COVER SHEET  
CIVIL PLANS

240 15TH STREET SE  
PUYALLUP, WA 98372

**FORTRESS - PUYALLUP**

# CONSTRUCTION DETAILS

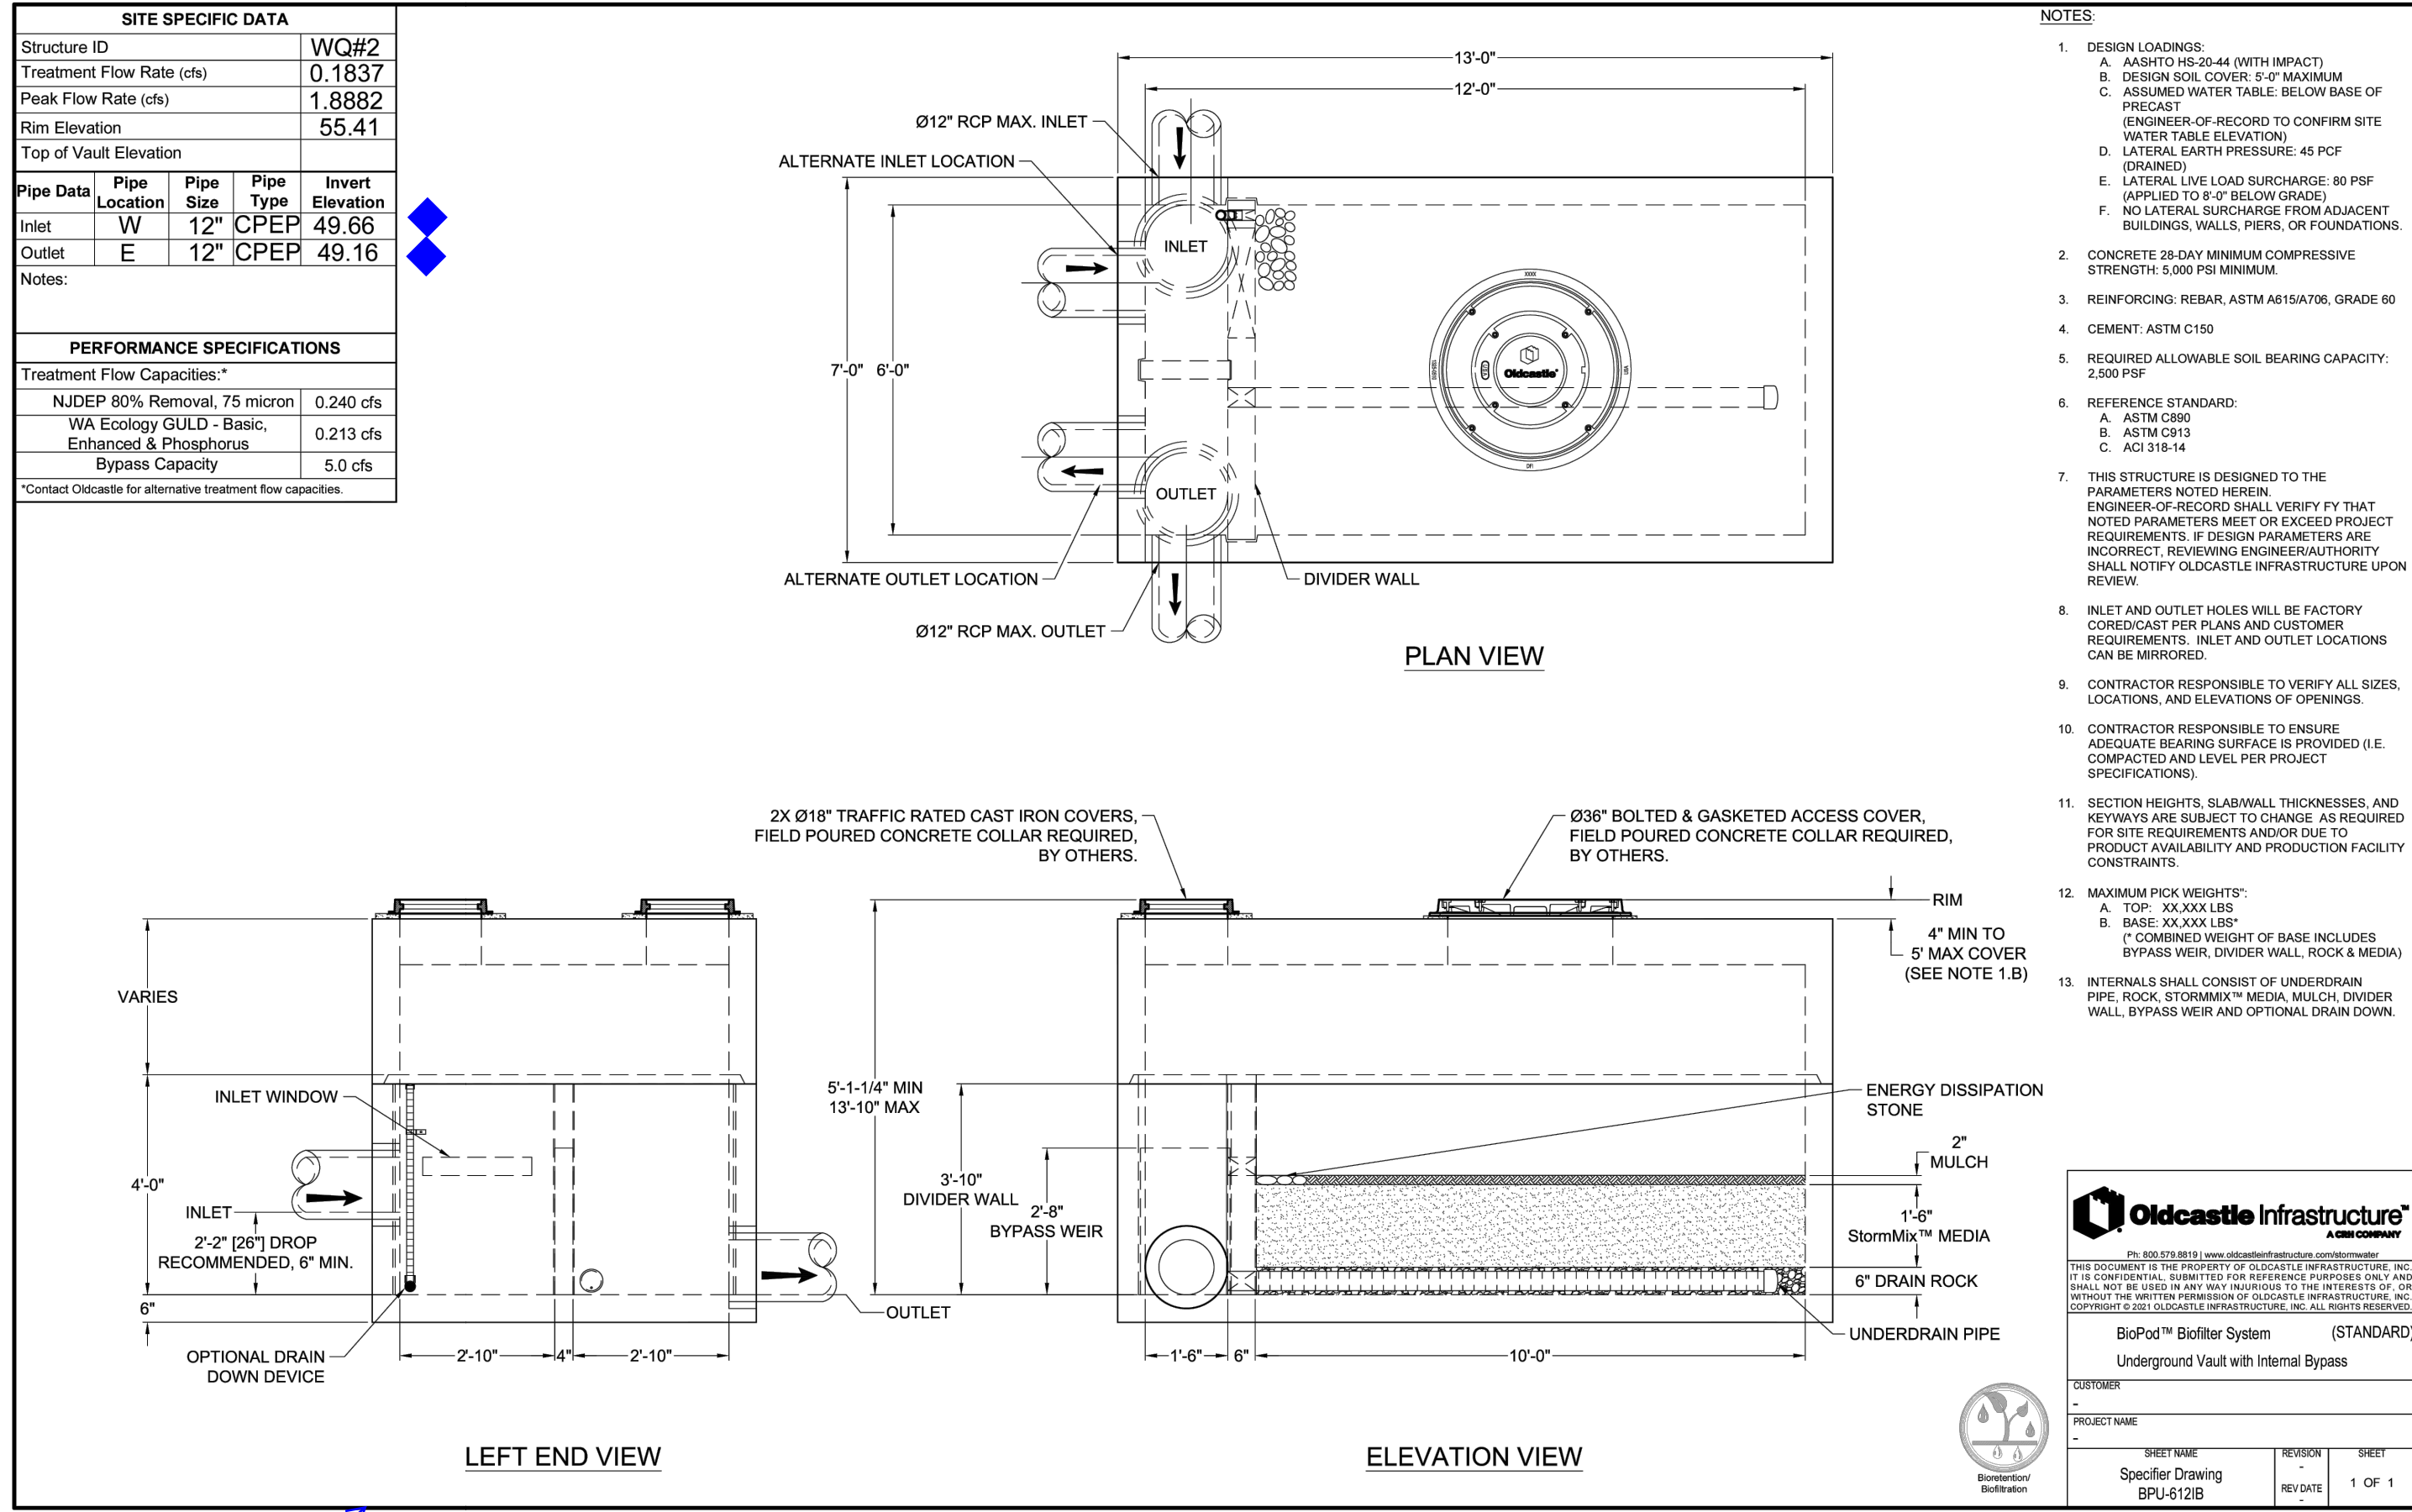
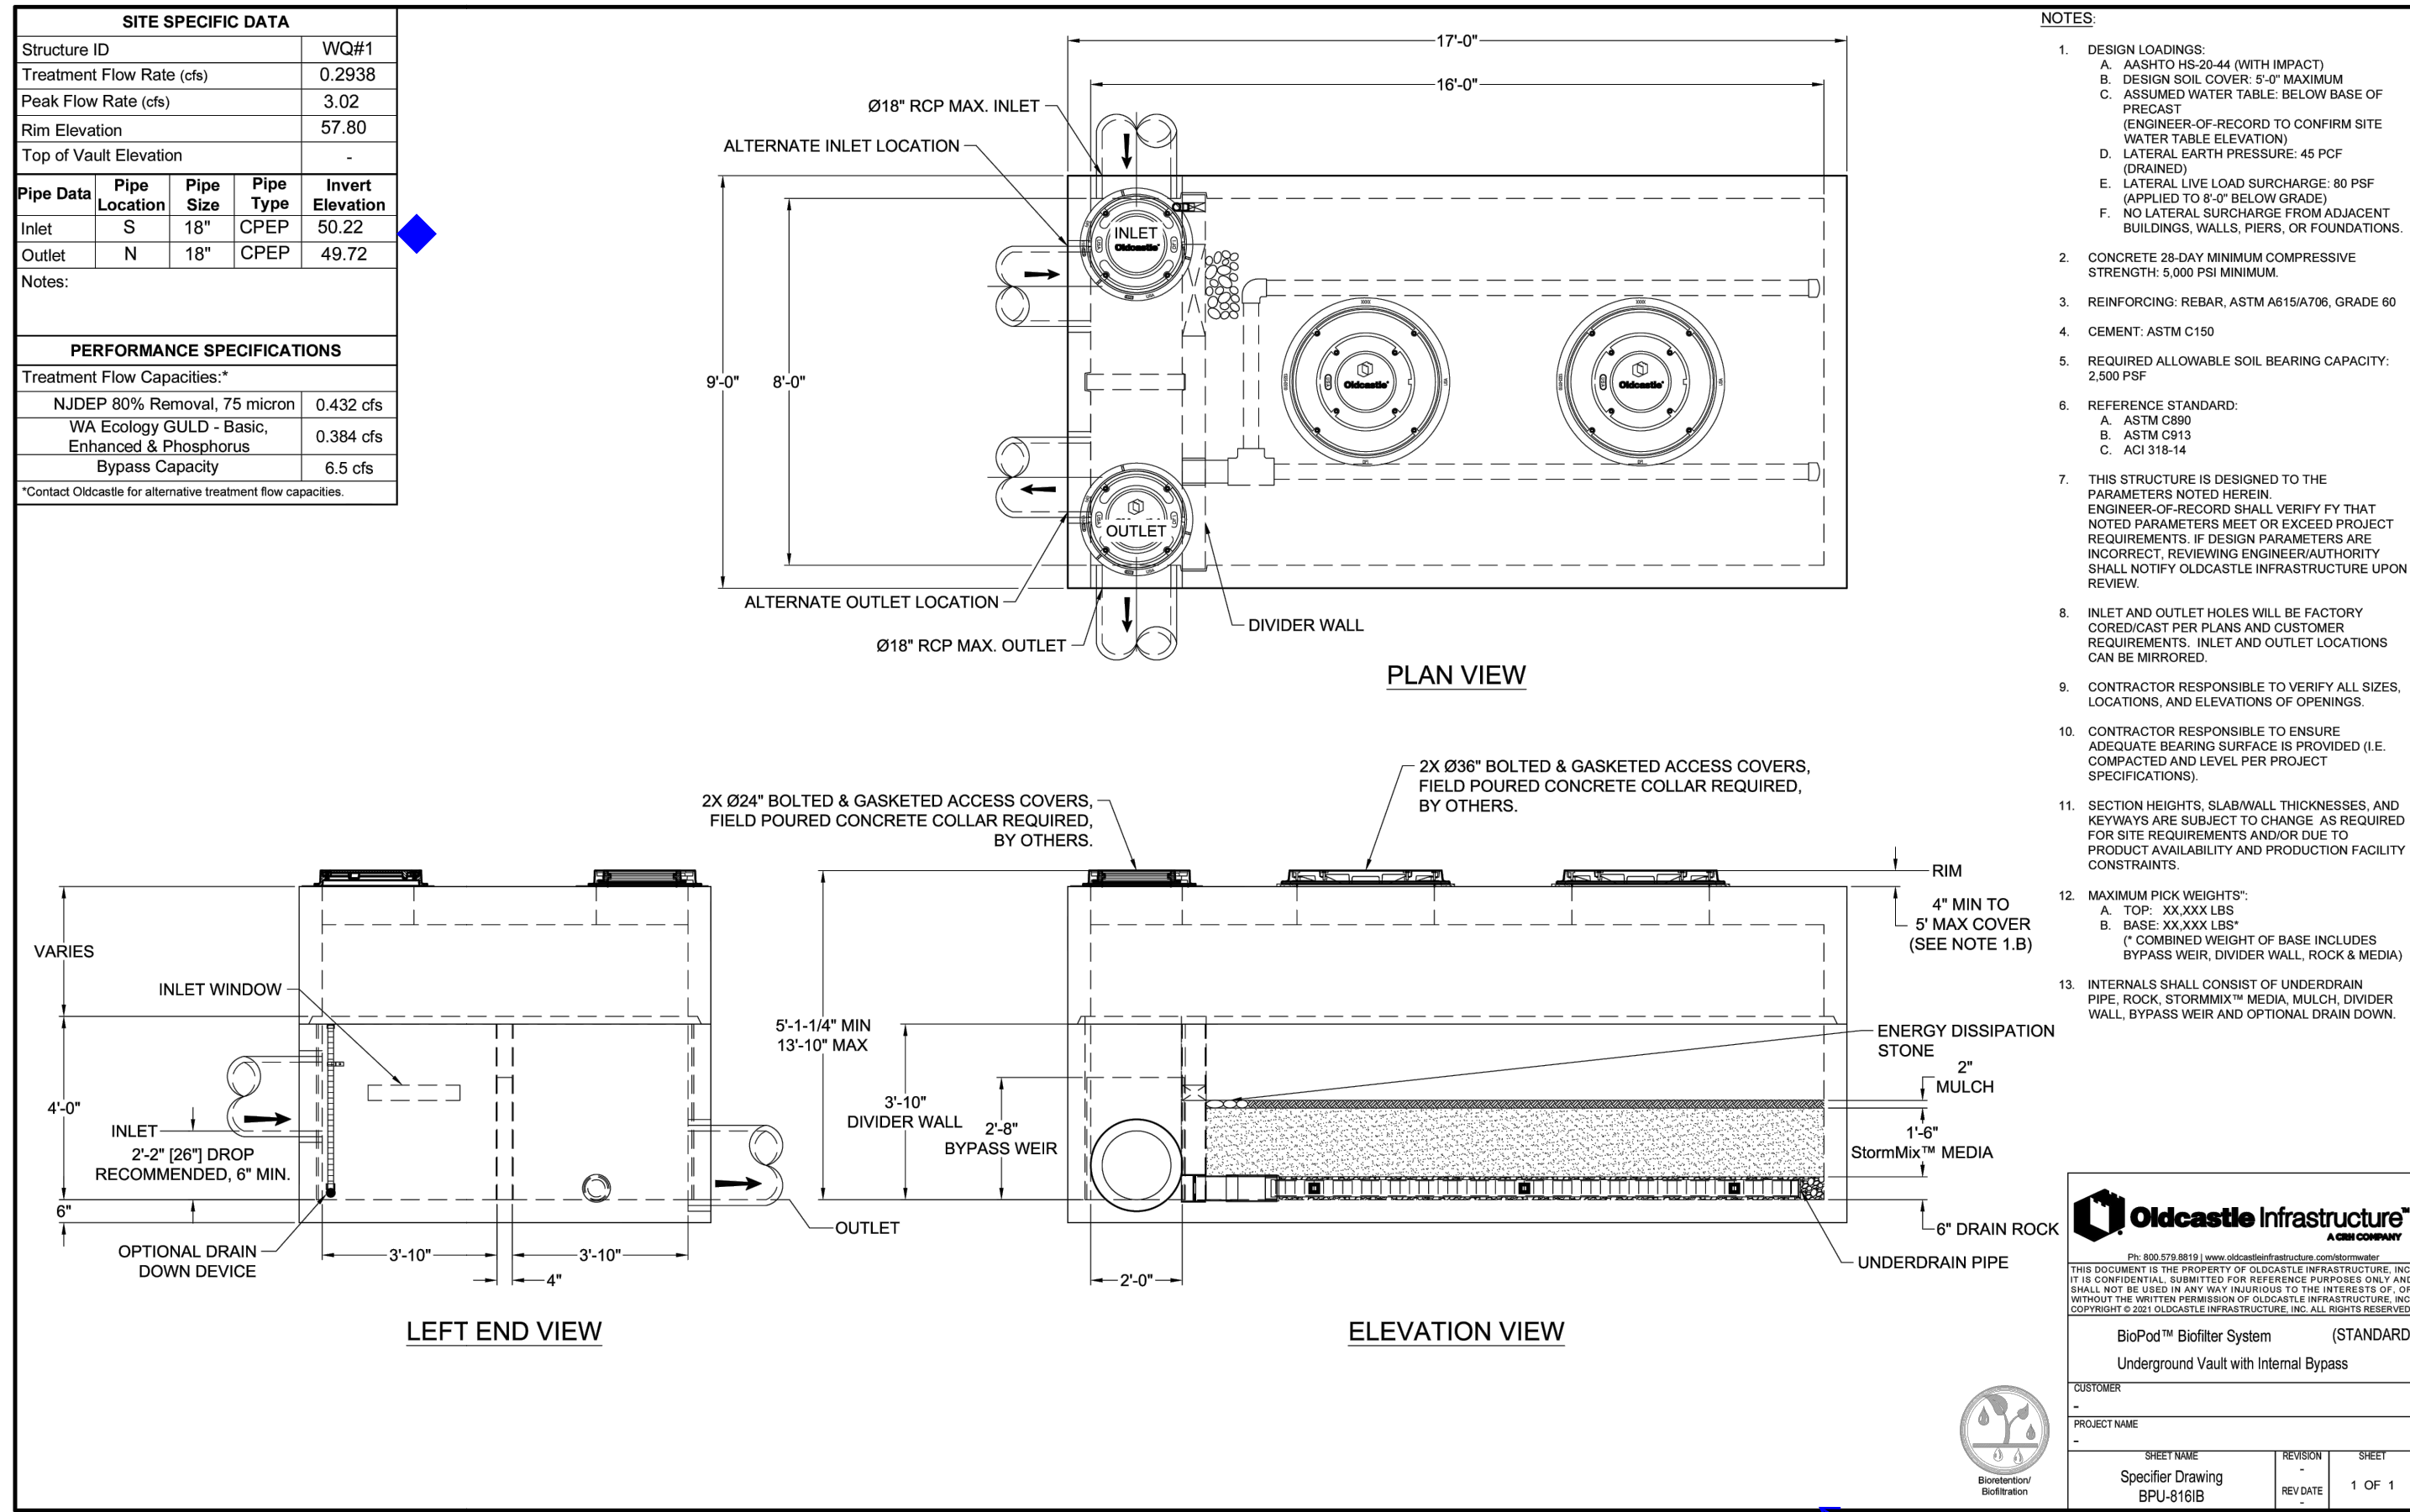
Denote WQ1 vs WQ2 details [civils, pg 20]
